Access Compliance Report Public Rights-of-Way (Curb Ramps)

Intersection ID: 24079 Main Street: LIVINGSTON MILL RD **Cross Street: MOSS RD** Location: NW ADA ID: 2C106C7A38CF Ramp Type: Perp Initial Pass/Fail: Pass **Overall Compliance: No Severity Score:** 15

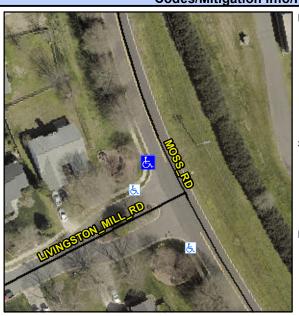
MOSS RD Street 1 Name Stop Condition-Street 2 None Street 2 Name N/A Stop Condition-Street 1 N/A Possible Solutions: Remove & Replace Entire Ramp. Remove & Replace Gutter. Surveyor Notes: N/A PROW/ADA: R304.2.1, R304.2.2-Perp, R304.3.2-Para, R304.5.3, R305.2, R304.5.4
